**Town of Kittery
Planning Board Meeting
May 23, 2024**

ITEM 1—90 US Route 1 Bypass—Major Site Plan — Final Review

Action: Approve plan or continue review. Geoff Aleva, on behalf of owner/applicants 90 US Route 1 LLC, requests approval to develop a hotel with 62 rooms and associated parking and utilities on the property of 90 US Route 1, Tax Map 14, Lot 2, in the Bypass-Old Post Road Commercial (C-3) Zone.

PROPOSED SITE PLAN

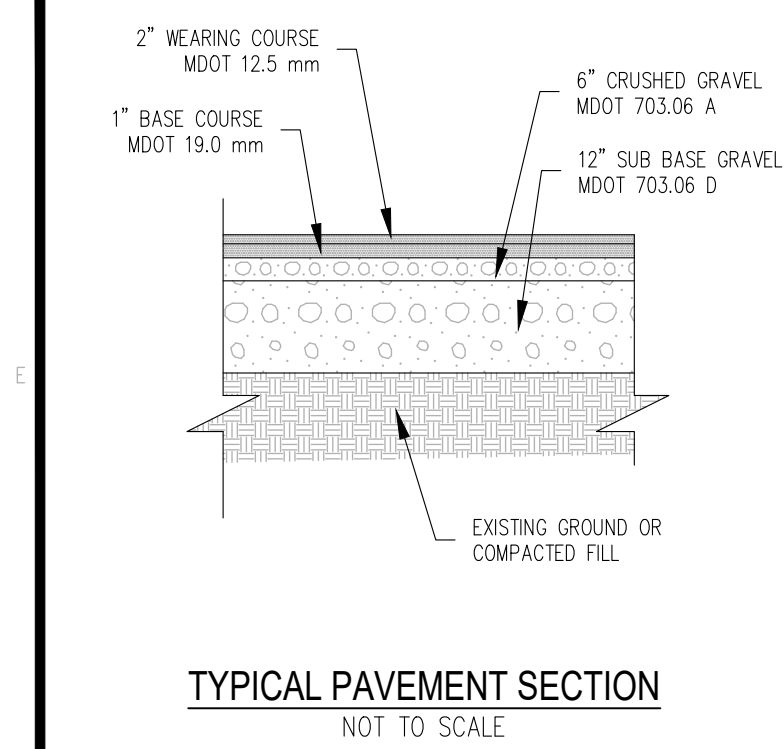
<p>We have the following comments on the plans: <u>Sheet L1 – Proposed Site Plan</u></p> <ol style="list-style-type: none"> There appears to be work in US Route 1 at the entrance with respect to tying into the existing pavement. Please provide additional information – notes, limits of work, details, striping, etc. to describe this area. This note remains unaddressed. 	<p>1. <i>See the sawcut line and callout added to sheet DEM for the limit of work in US Route 1. There is existing striping on US Route 1 in front of the proposed development that will not be altered by the work.</i></p>
<p><u>Sheet U1 – Utility Plan</u></p> <ol style="list-style-type: none"> Provide information on directional drilling of water main. The applicant indicates they are coordinating with Kittery Water District. Show the location of the gate valve. The applicant indicates they are coordinating with Kittery Water District. 	<ol style="list-style-type: none"> <i>The applicant will be working with the Kittery Water District to complete the directional drilling and waterline improvements.</i> <i>The gate valve locations have been added to sheet L1. The final locations will be coordinated with the Kittery Water District.</i>
